State University of New York College at Cortland
Old Main ADA Bathroom Upgrades
Project No. 20240032

ADDENDUM NO. 4

RFI LOG AND RESPONSES

A151

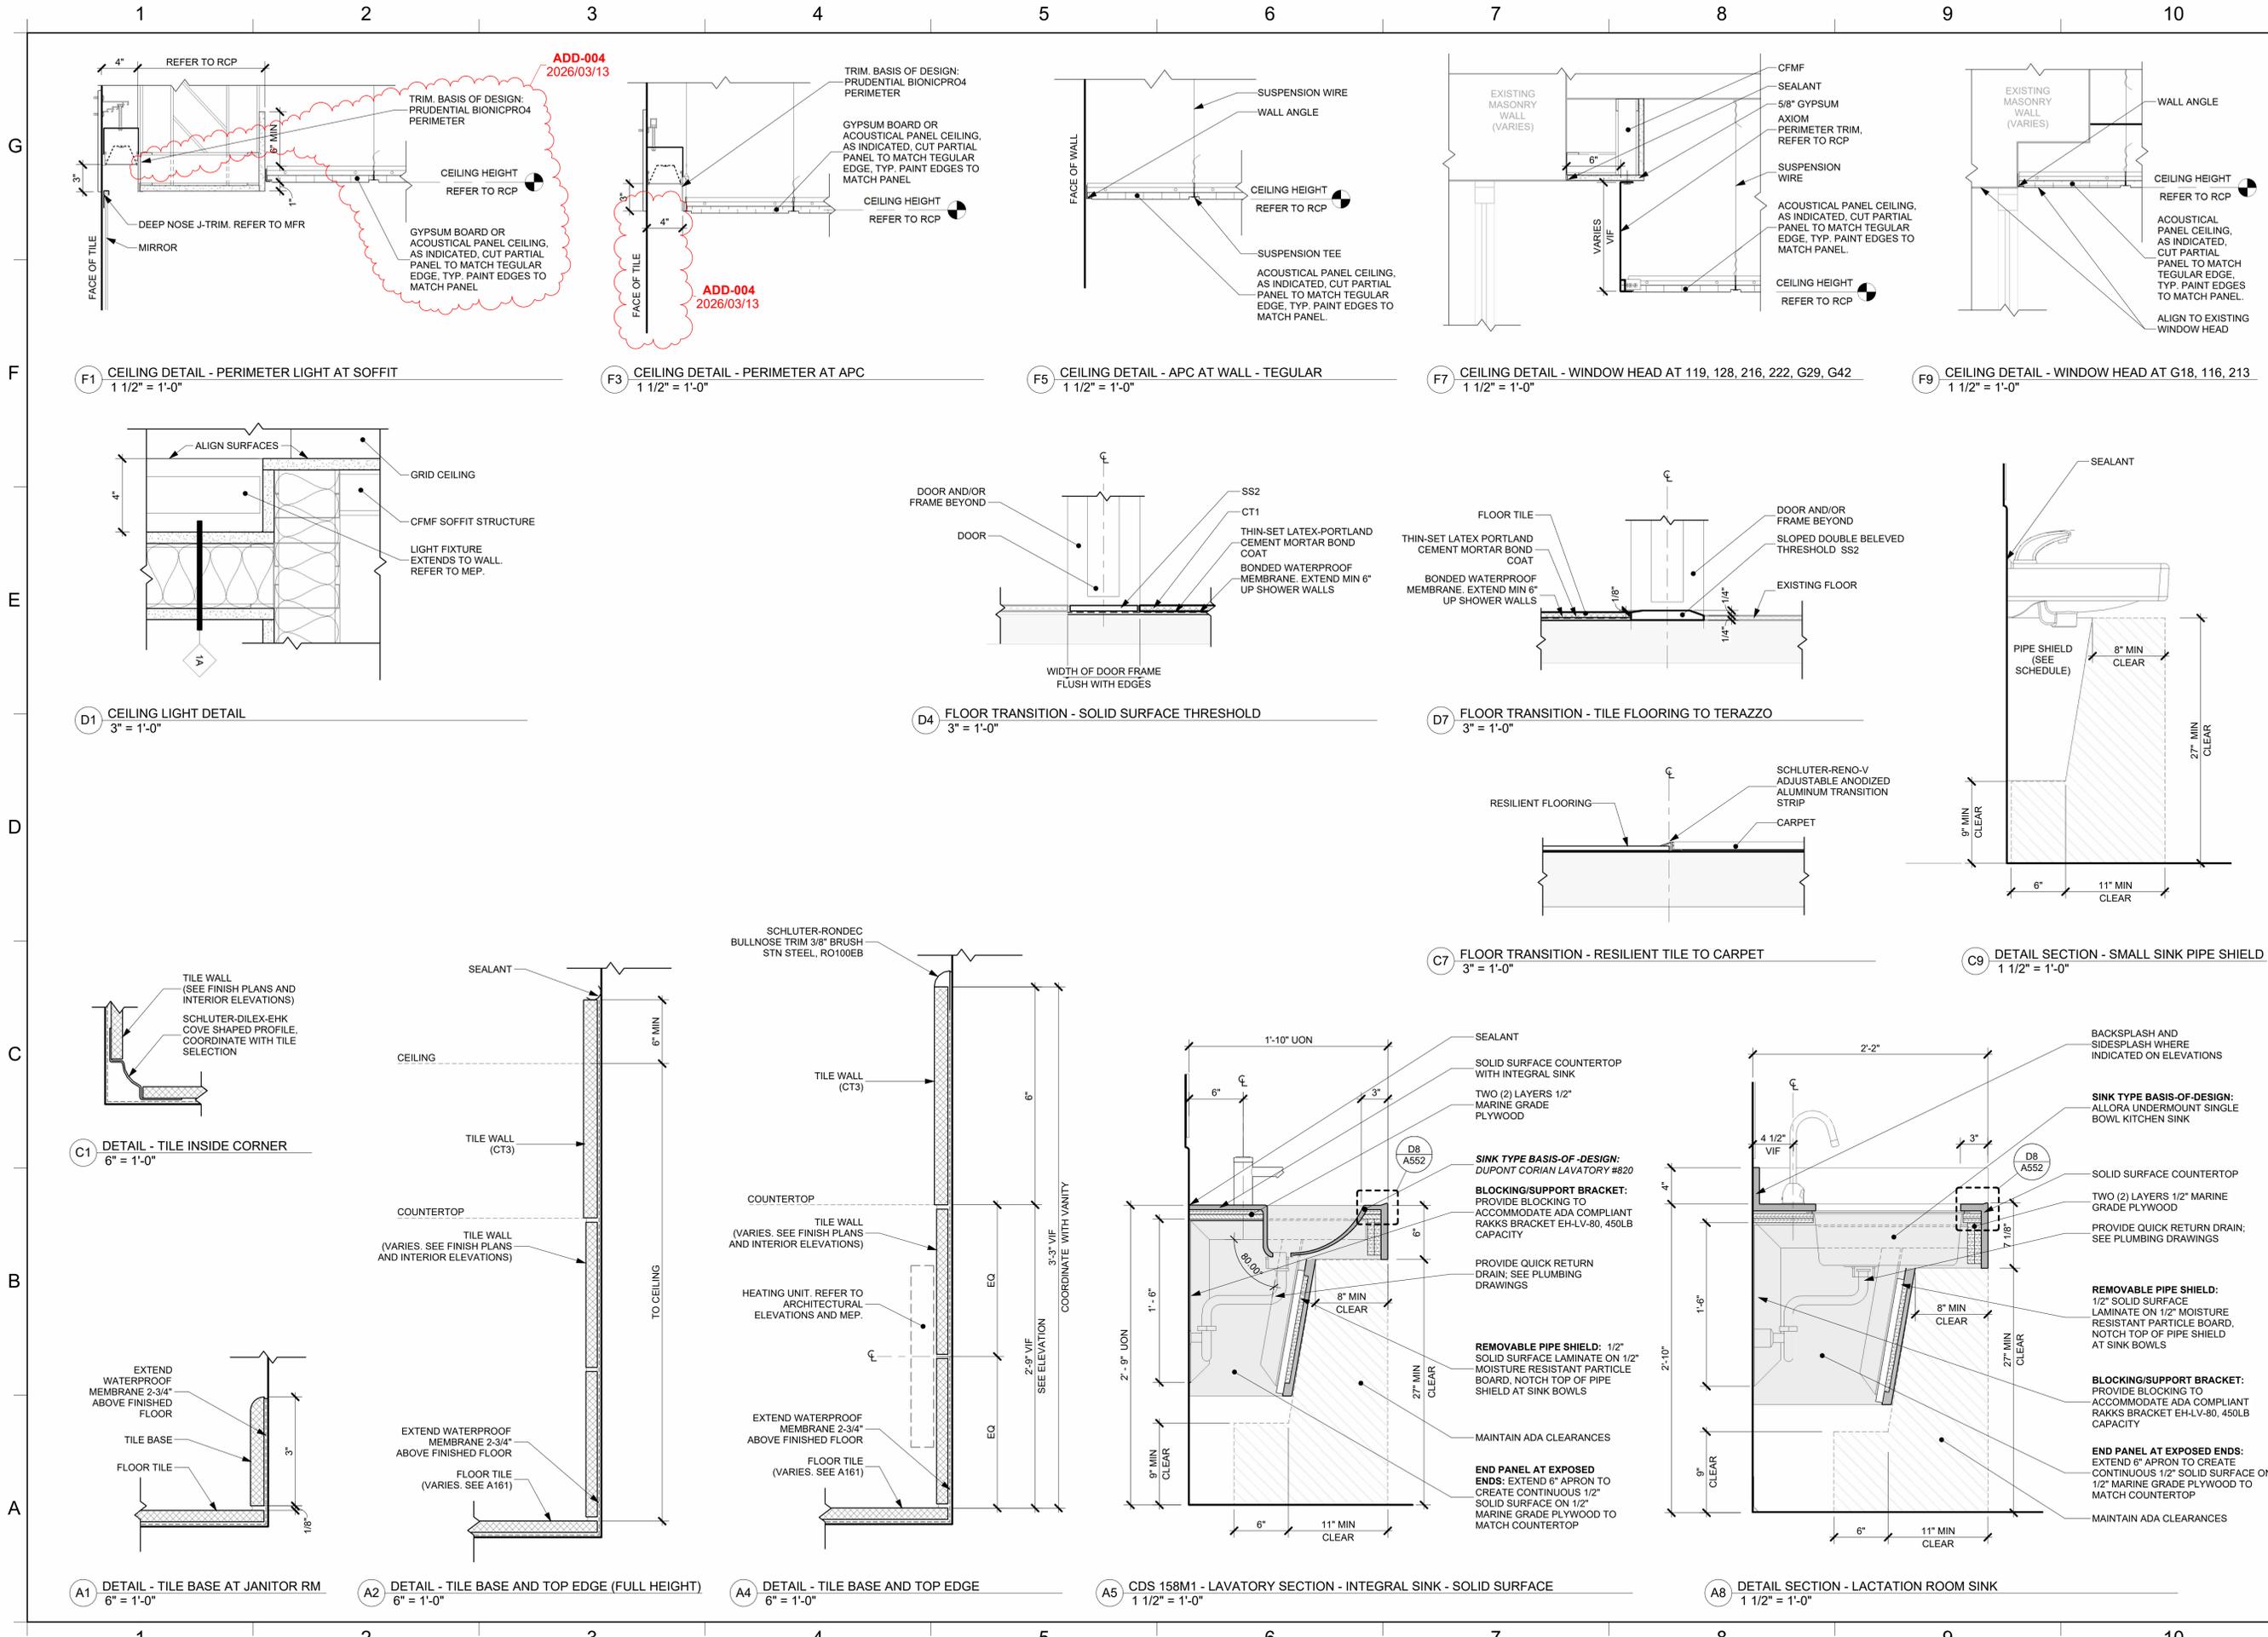
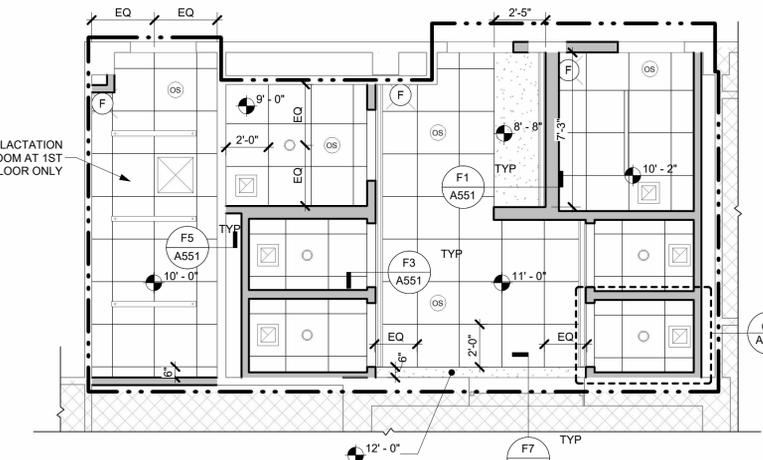
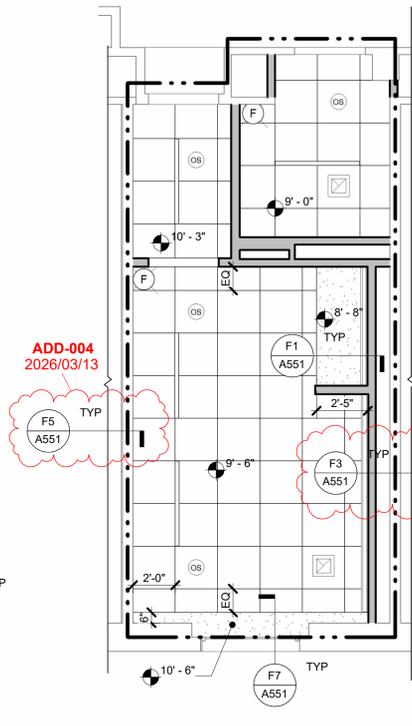
10	A551 Ceiling Details F1 & F3 indicate the Prudential Bionic Pro4 trim. On A151 in details E4, E7, 2, & A4 have the trim drawn but not noted for either RCP Detail F1 or F3. Provide clarification.	Streeter Associates	3/9/26		Addendum 4	See Addendum 4
11	SS3 called out on A552. Not listed on Finish Schedule. Please advise what material SS3 is.	GM Crisalli	3/11/26		Addendum 4	That is a typo and should read SS1. See Addendum 4.
12	Is the intent to replace all Analog devices to the new signature Devices ?	Everon	3/10/26		Addendum 4	Yes
13	The request for the 4 new loop controllers to be added are no longer available from the fire alarm manufacture, how do you want us to proceed with this request ?	Everon	3/10/26		Addendum 4	SUNY Cortland will provide the 4 loop controllers.
14	Is the intent to Upgrade the existing EST-3 panel to a New EST-4 system ?	Everon	3/10/26		Addendum 4	Not in the base bid. Upgrading to an EST-4 will be an add alternate. See Addendum 4.
